# CITY OF ALBUQUERQUE

RE: **Lot 12 Block 5, Volcano Cliffs, Unit 19, SAD 228  
6511 Azor NW  
Grading and Drainage Plan  
Engineers Stamp Date 4/3/20 (D10D003H12)**

ENGINEER'S SEAL	LOT 12 BL 5 U19 VOLCANO CLIFFS 6511 AZOR LANE	DRAWN BY DEM
		DATE 4-2-20
		GRADING AND DRAINAGE PLAN
		SHEET # C1
DAVID SOULE P.E. #14522		JOB #

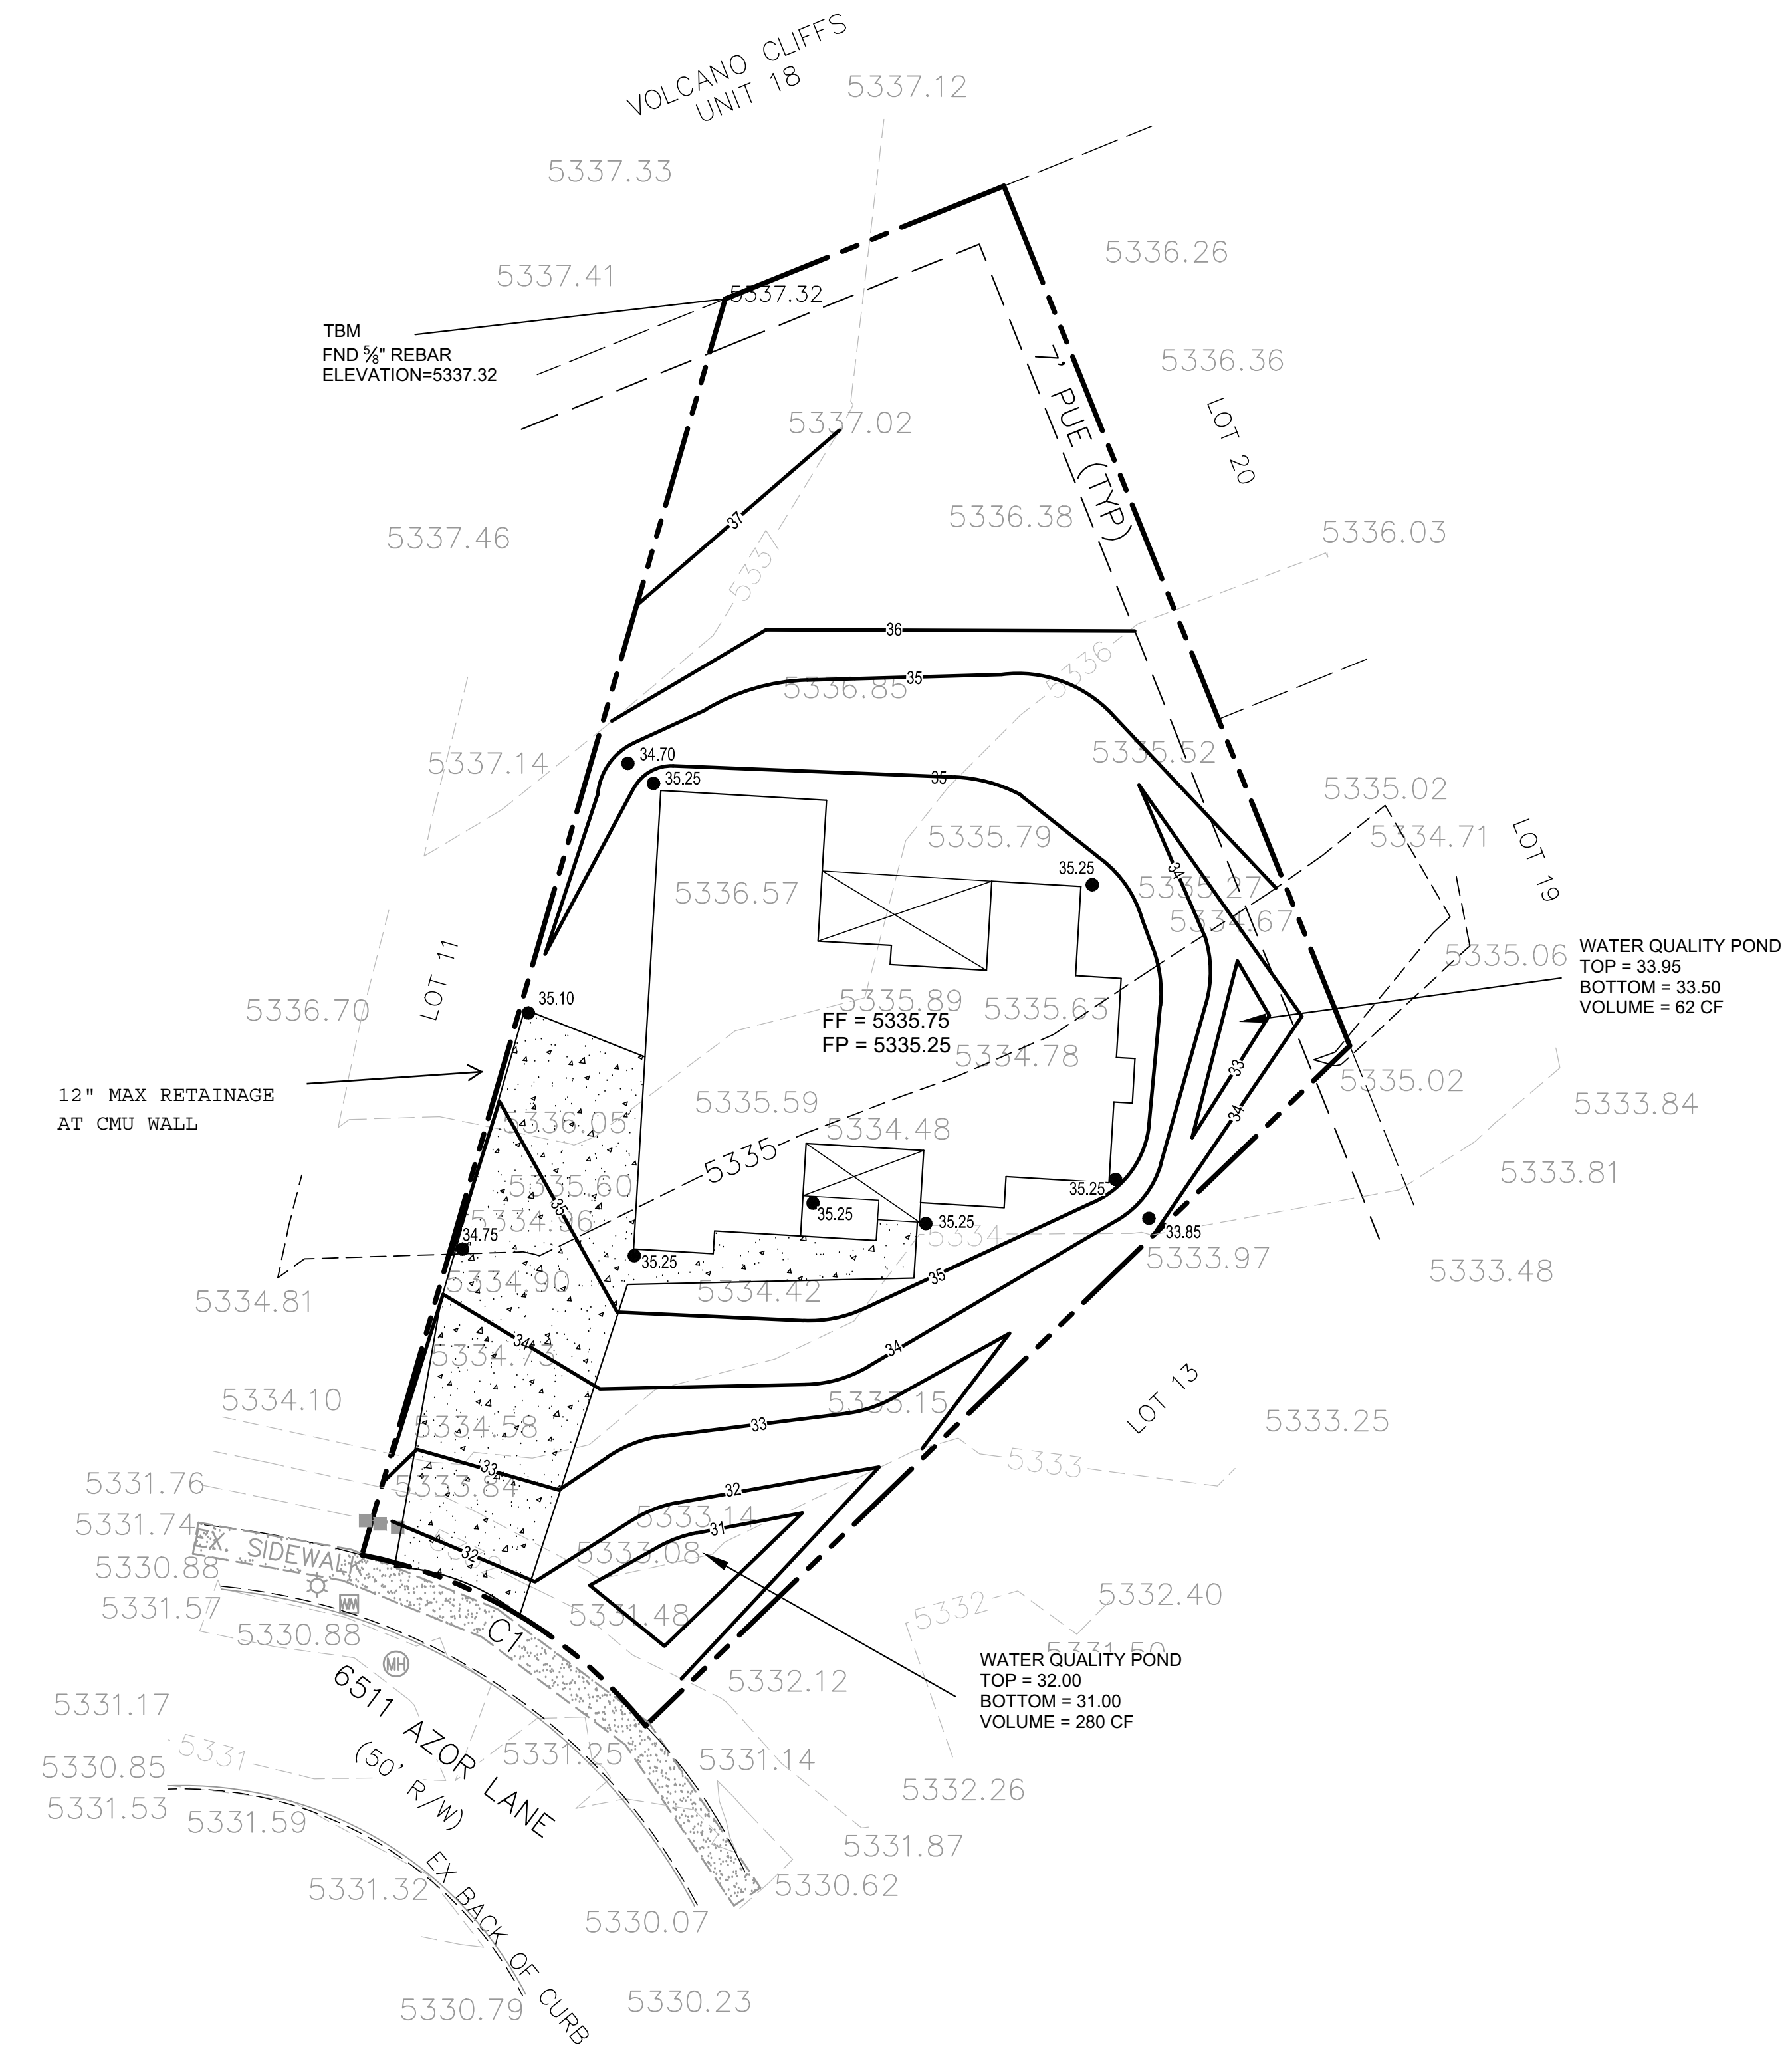
Based upon the information provided in your submittal received 4/3/20, this plan is approved for Grading Permit.

**Prior to Building permit approval a Pad Certification will be required, provided by the Engineer or a registered Land Surveyor.**

**Advise the owner contractor not to use dirt as a ramp to climb the curb, use lumber or crusher fines for this purpose.**

Reiterate to the Owner/Contractor that a separate permit for a garden/retaining wall must be obtained with the approved G&D plan and Pad Certification. Also, if a swimming pool is to be placed the grading and drainage plan will change and will need to be resubmitted.

**Prior to Certificate of Occupancy release, Engineer Certification per the DPM checklist is required.**
